**2017 Edwards Aquifer Recharge Zone (EARZ) Cured In Place Pipe (CIPP) Construction Contract
Solicitation Number: CO-00130
Job No.: 17-4536**

**ADDENDUM 2
June 5, 2017**

REVISIONS			
No.	Revision	Drawn	Approved
	ADDENDUM 1	SKD	SKD
			6-1-17
 DEER MOUNTAIN ST SEWER REHAB PROJECT SEWER LAYOUT & CIPP PLAN			
DEVELOPER:		BUDGET PROJ.	
CONT.			
SUBMITTED			
APPROVED			
MAP No.	JOB No. 16-4523		SHEET
SECT. No.			6
DR. JG	CK. SKD		OF 7

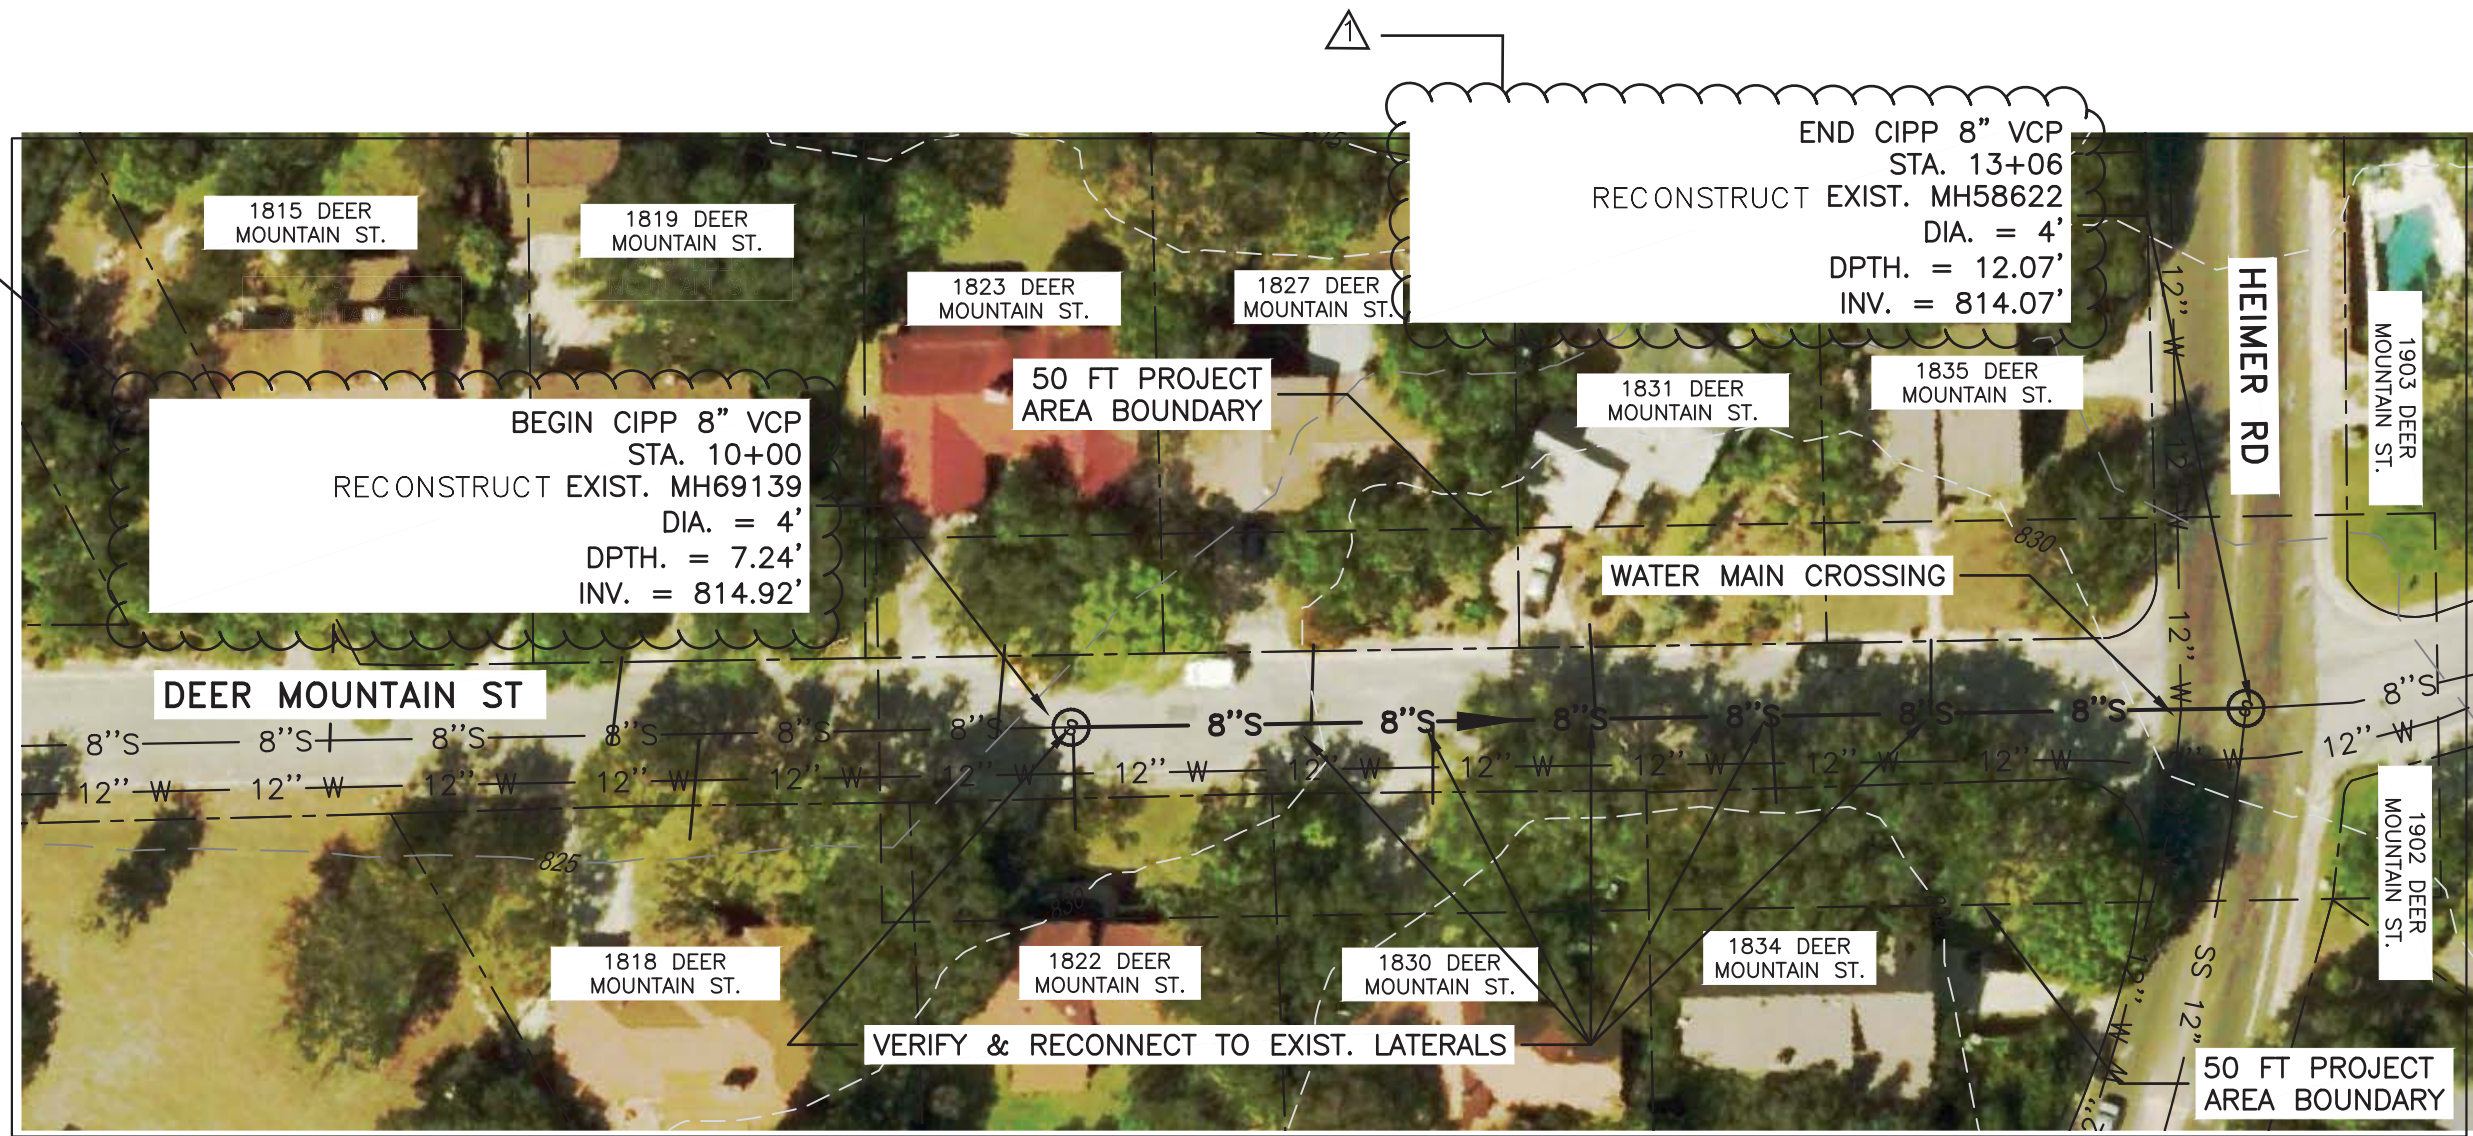
2. 1822 Deer Mountain, Sheet 6: Quantity table is revised to add item 530.1, Barricades, Signs, and Traffic Handling. This item was already included in Bid Proposal items. Quantity table is also revised to replace Item 852 "Replace Existing Manhole Ring and Cover" with Item 855 "Reconstruction of Existing Manhole" and add pavement restoration items. Remove and replace sheet 6 in its entirety with the revised sheet attached.

ADDENDUM 1	SKD	SKD	6-1-17
Revision	Drawn	Approved	Date
REVISIONS			
HEIMER ROAD SEWER REHAB PROJECT			
DEVELOPER:		BUDGET PROJ.	
CONT.			
SUBMITTED			
APPROVED			
MAP No.			SHEET
SECT. No.			6
DR. JG	CK. SKD	JOB No. 16-076	OF 8

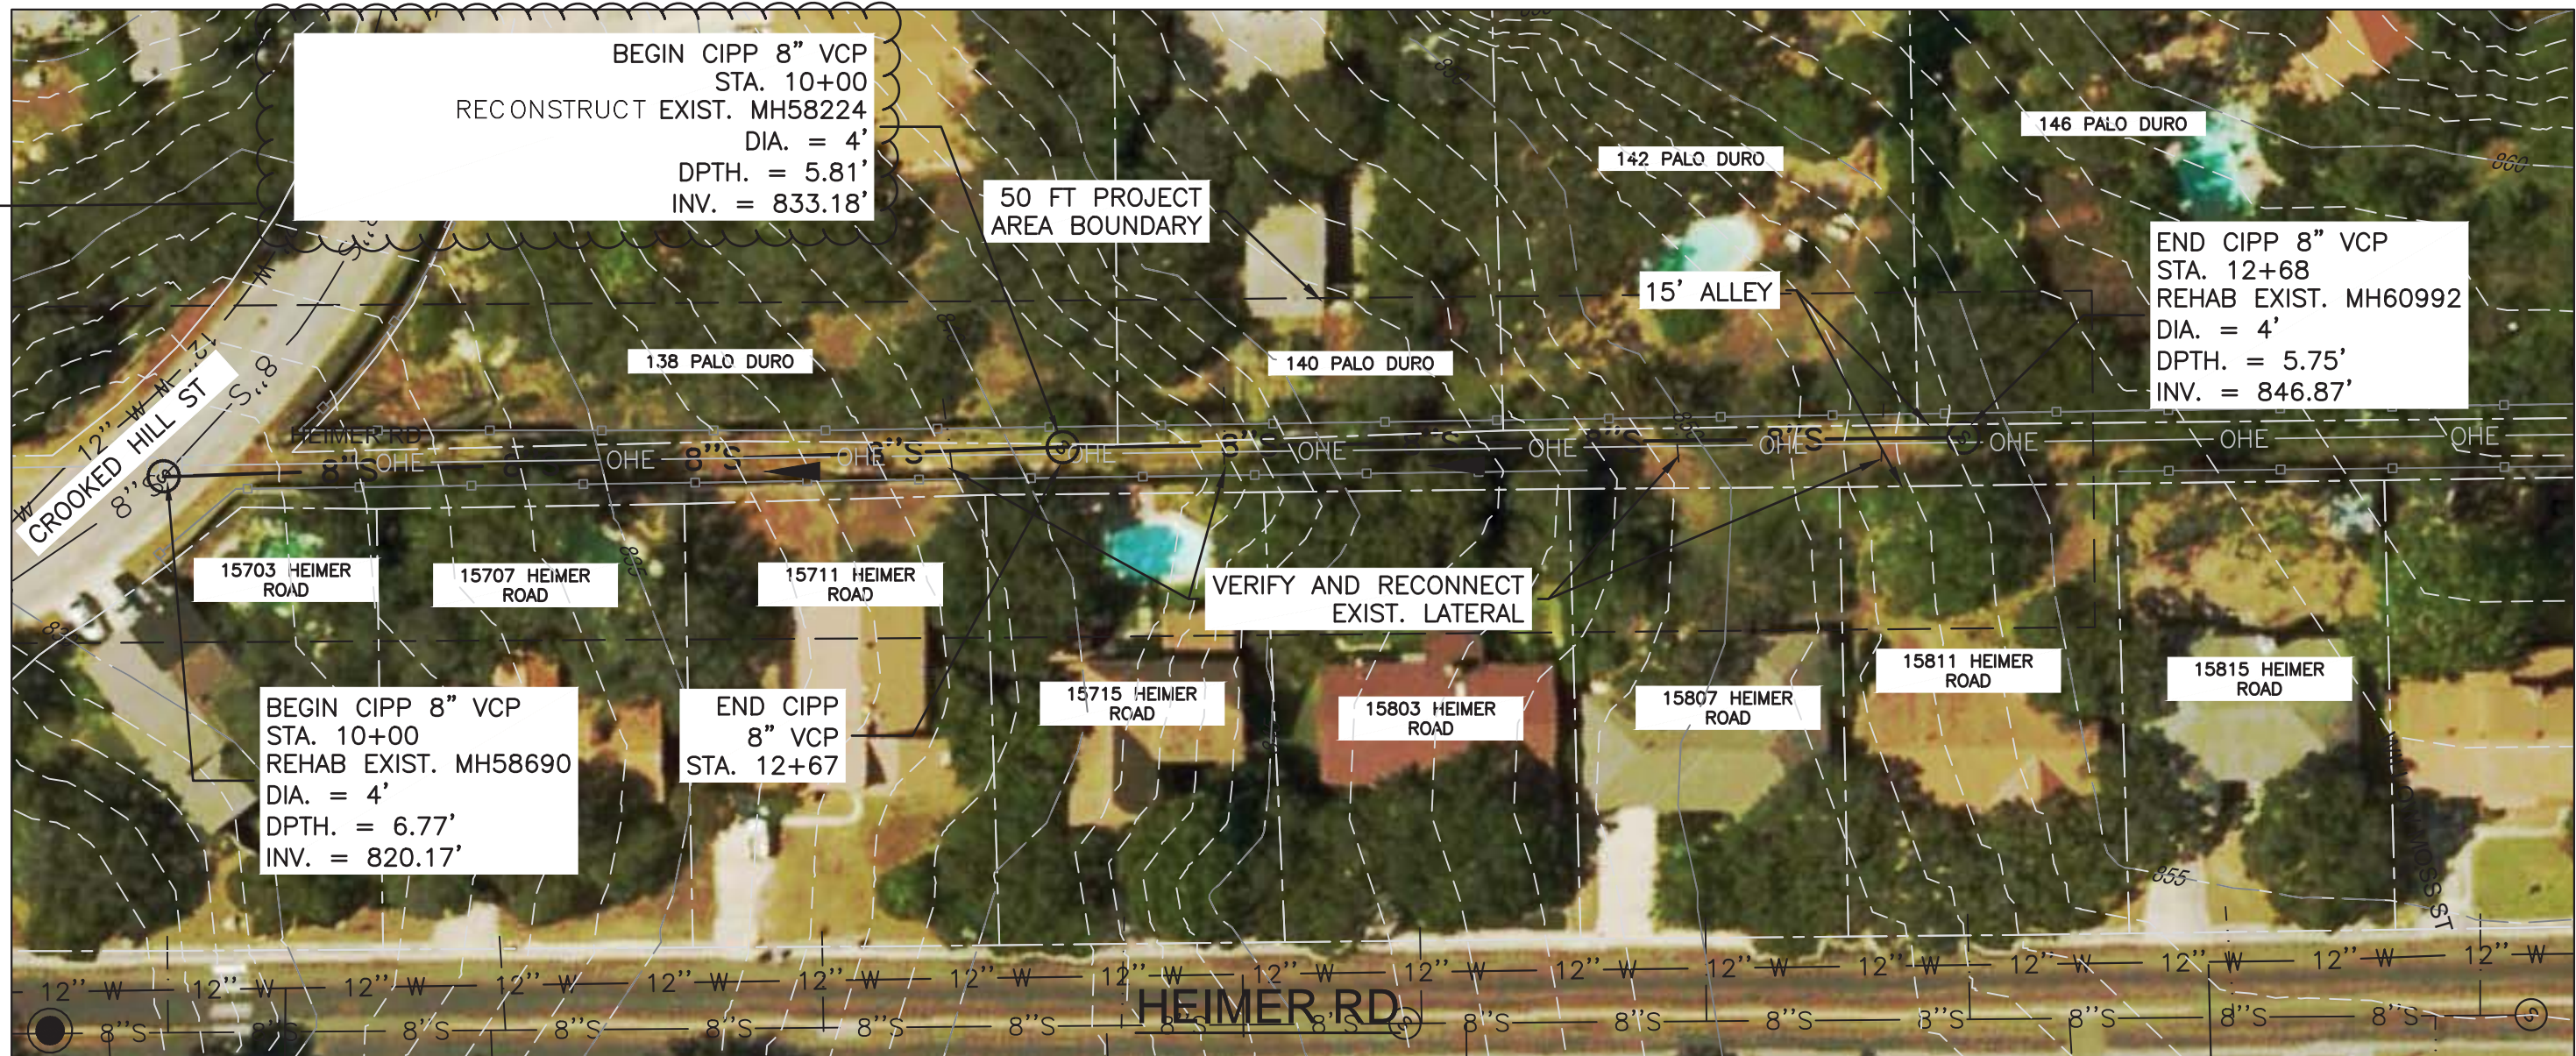
4. 15800 & 15715 Heimer Road, Sheet 6: Quantity table is revised to add item 530.1, Barricades, Signs, and Traffic Handling. This item was already included in Bid Proposal items. Quantity table is also revised to replace Item 852 "Replace Existing Manhole Ring and Cover" with Item 855 "Reconstruction of Existing Manhole". Remove and replace sheet 6 in its entirety with the revised sheet attached.

HEIMER ROAD SEWER REHAB PROJECT SEWER LAYOUT & CIPP PLAN			
DEVELOPER:		BUDGET PROJ.	
CONT.		BUDGET PROJ.	
SUBMITTED			
APPROVED

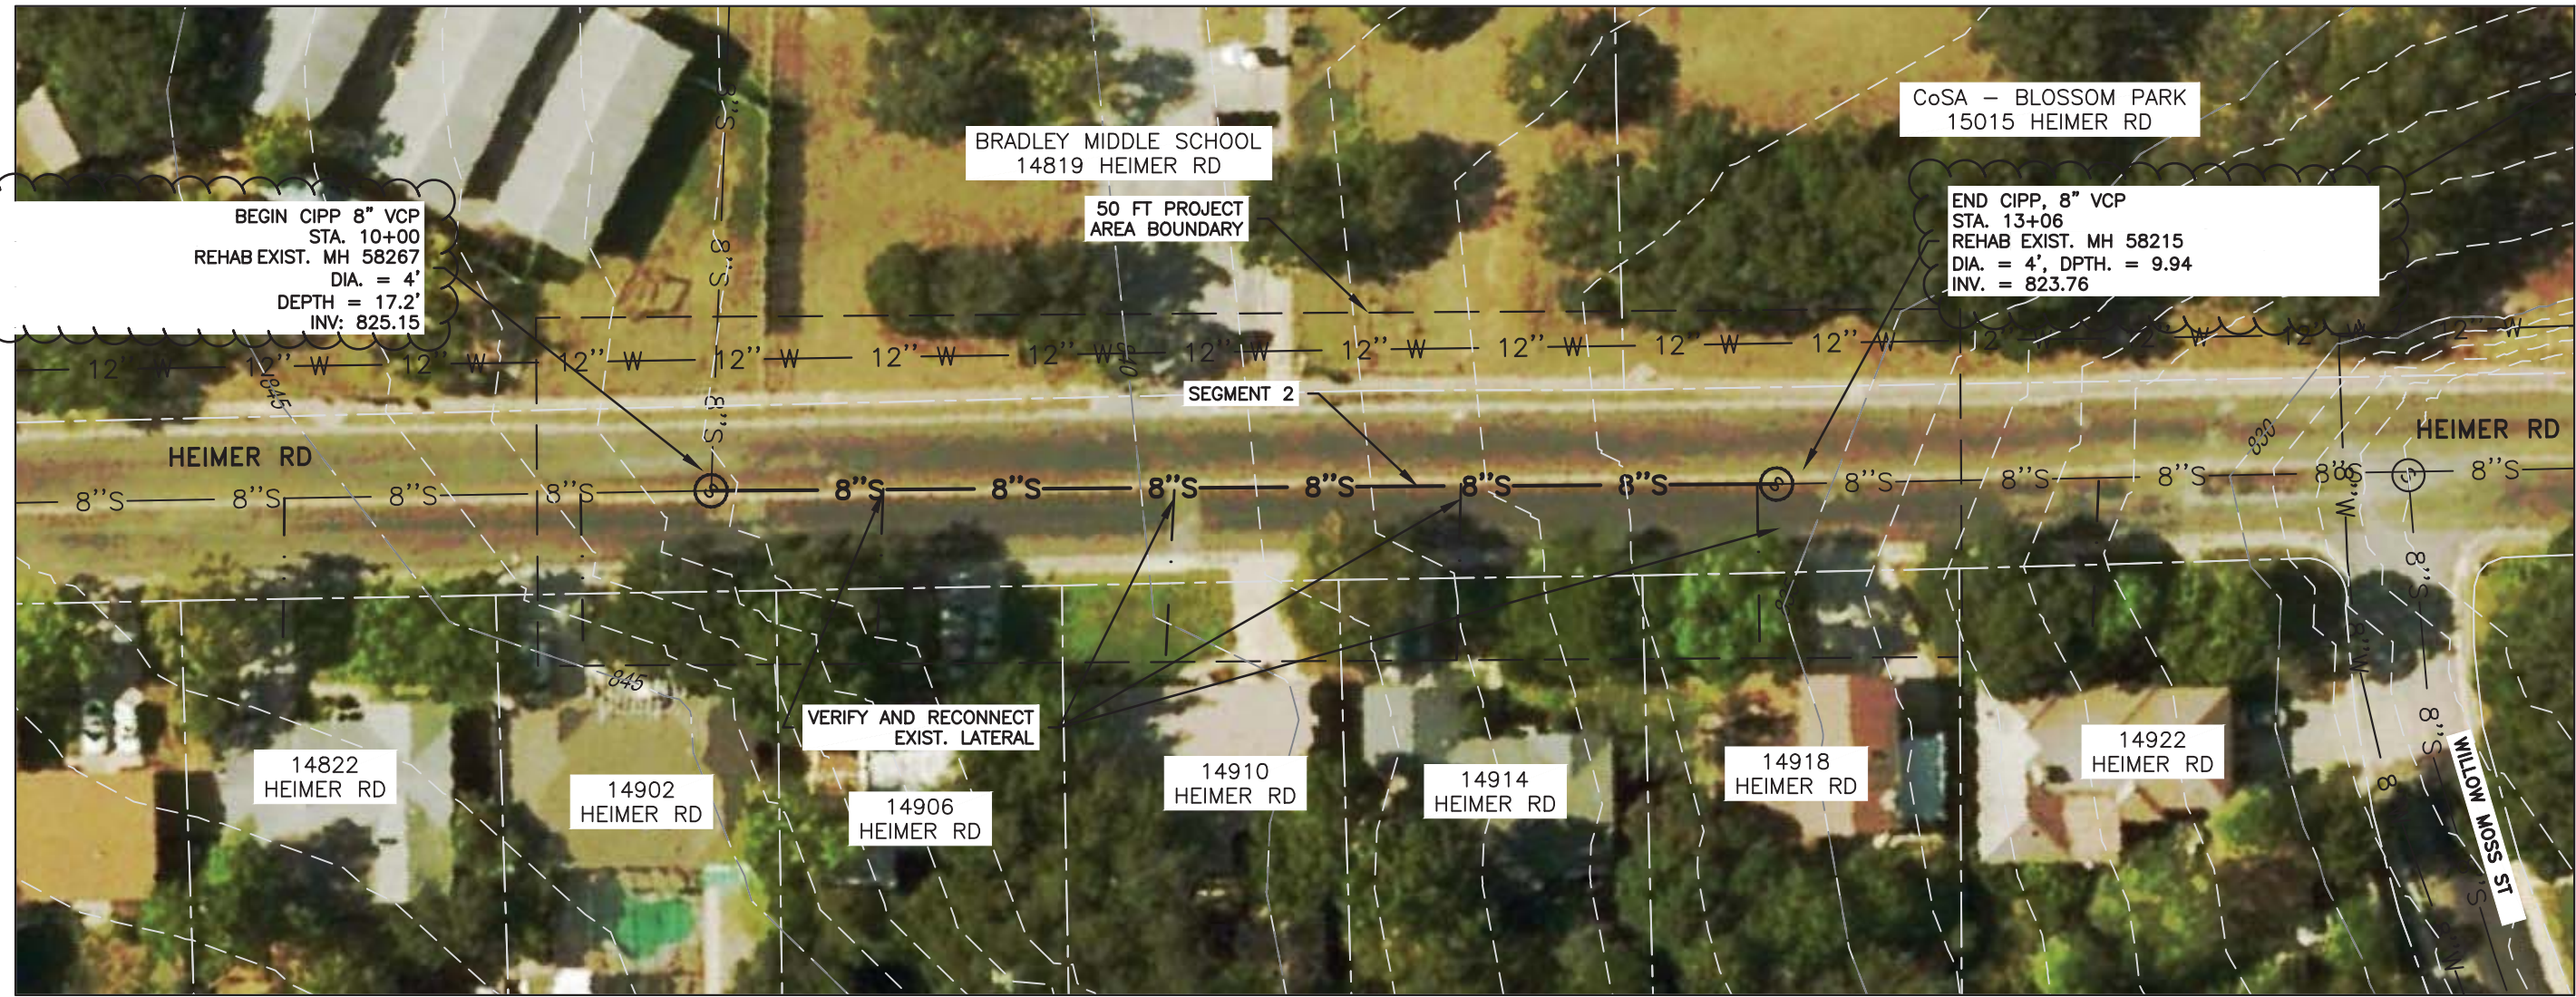
7. 14902 Heimer Rd, Sheet 6: Quantity table is revised to add item 530.1, Barricades, Signs, and Traffic Handling. This item was already included in Bid Proposal items. Quantity table is also revised to remove Item 852 "Replace Existing Manhole Ring and Cover". Remove and replace sheet 6 in its entirety with the revised sheet attached.

ADDENDUM 1	SKD	SKD	6-1-17
No.	Revision	Drawn	Approved
REVISIONS			
ENGLEMANN SEWER REHAB PROJECT SEWER LAYOUT & CIPP PLAN			
DEVELOPER:			
CONT.		BUDGET PROJ.	
SUBMITTED _____			
APPROVED _____			
MAP No.			SHEET
SECT. No.			6
DR. JG	CK. SKD	JOB No. 17-4515	OF 9

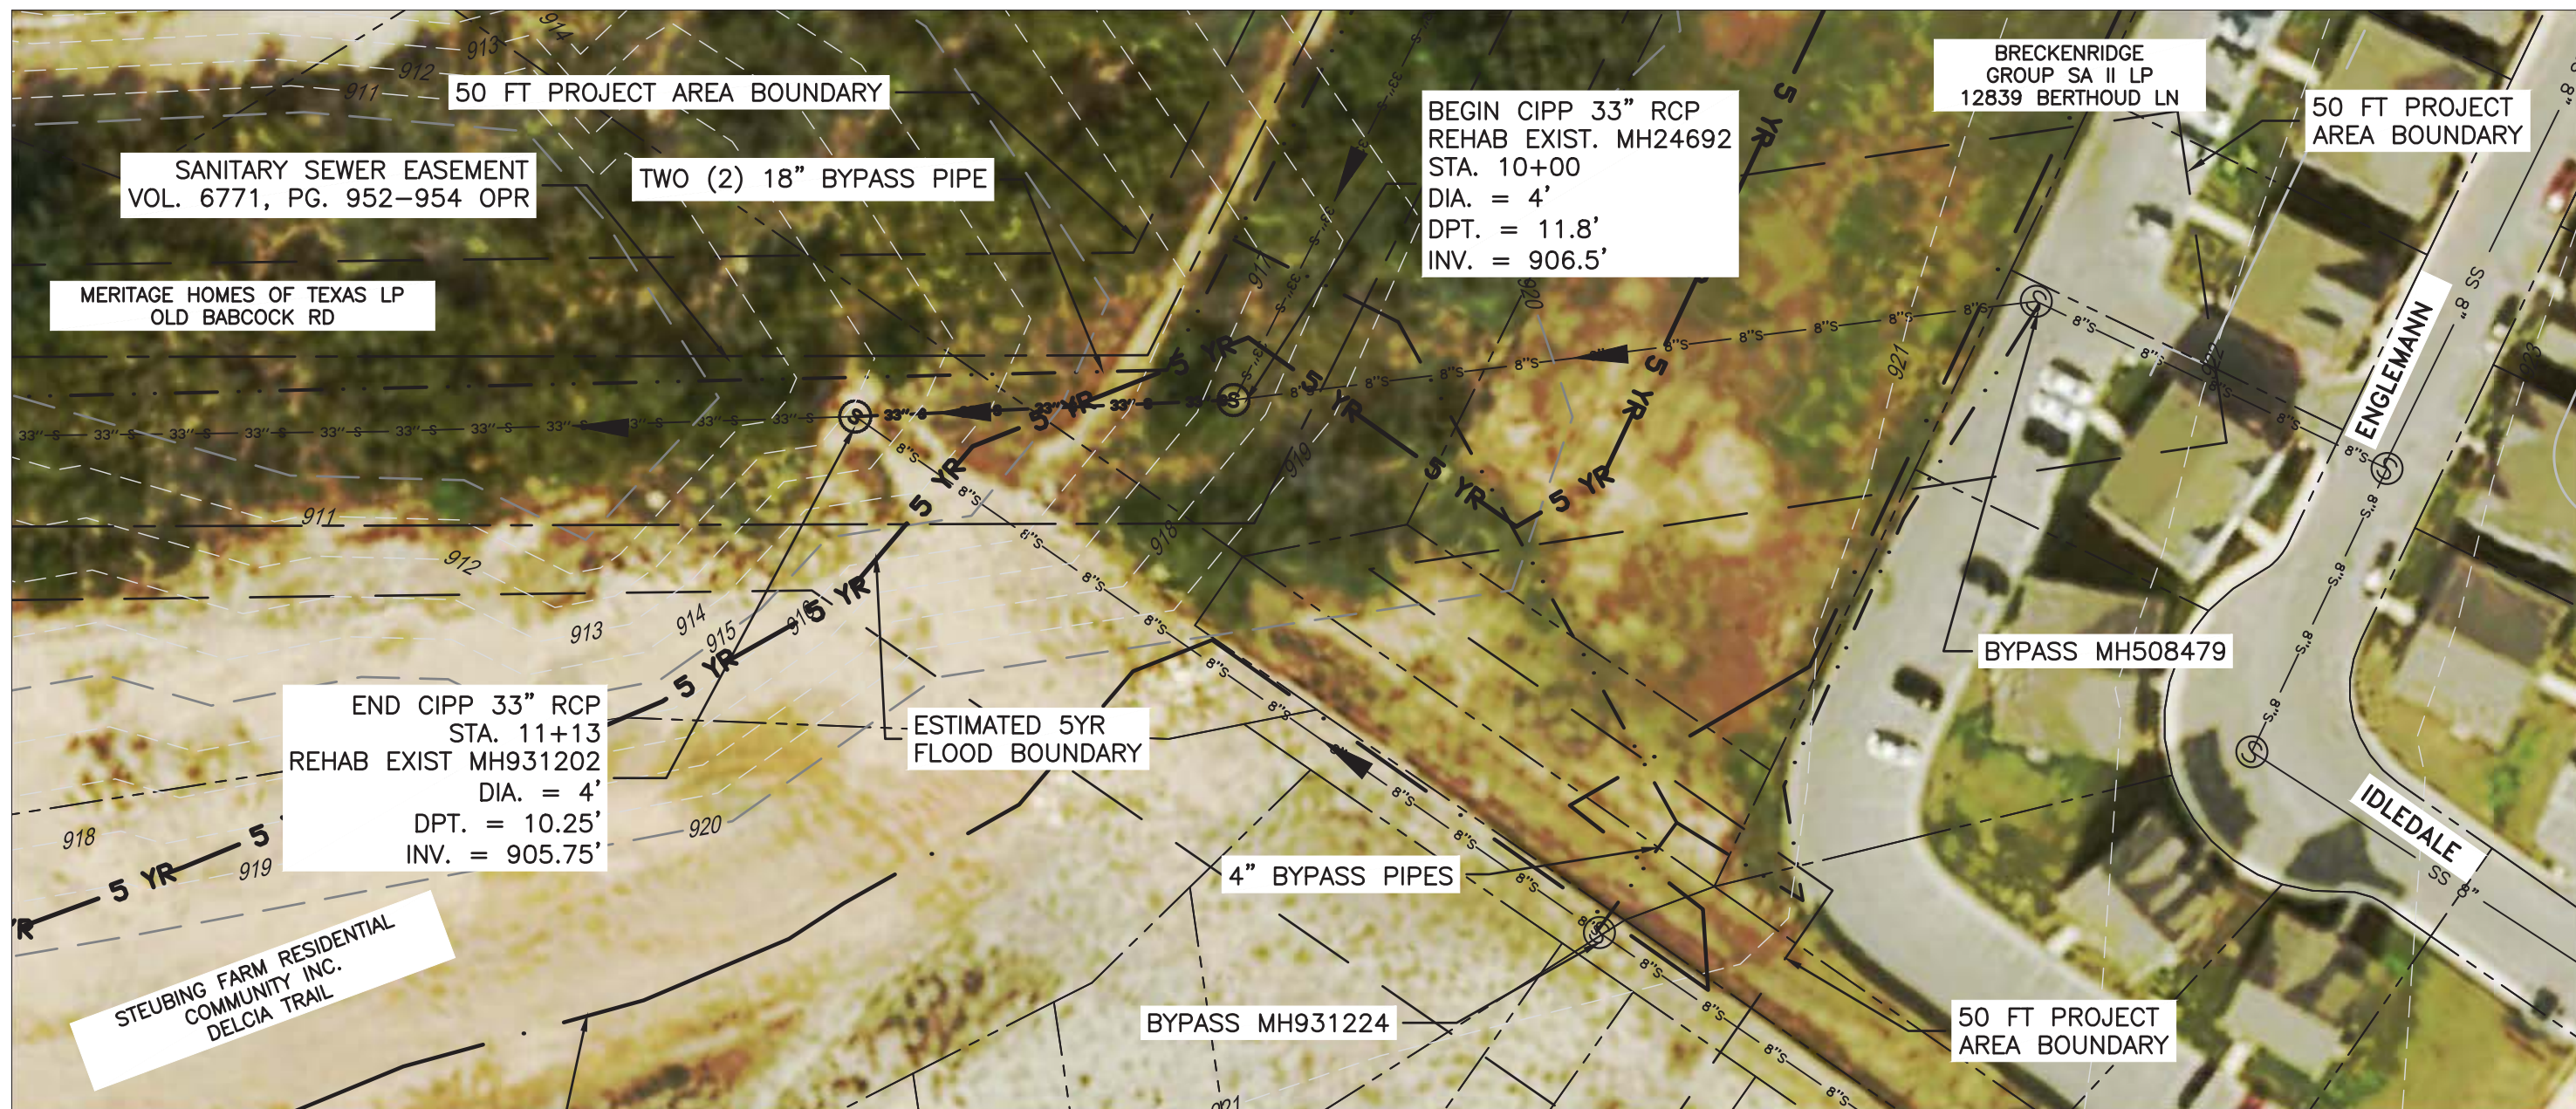
20. **The 12703 Englemann area quantities shown on sheet 6 appear to call for 2 manholes to be reconstructed, but that work does not appear to be designated at any manholes shown on the drawings. Which 2 manholes are being reconstructed in this area?**

9. 12703 Englemann, Sheet 6: Quantity table is revised to add item 530.1, Barricades, Signs, and Traffic Handling. This item was already included in Bid Proposal items. Quantity table is also revised to increase number of Reconstructed Manholes. Remove and replace sheet 6 in its entirety with the revised sheet attached.

Response: Reconstruction in Englemann is anticipated to be required for CIPP and bypass access. Quantities have been revised to a total of four (4) to reflect CIPP start and end and Bypass suction and discharge. See Changes to Specifications Item 2 and Changes to Plans .
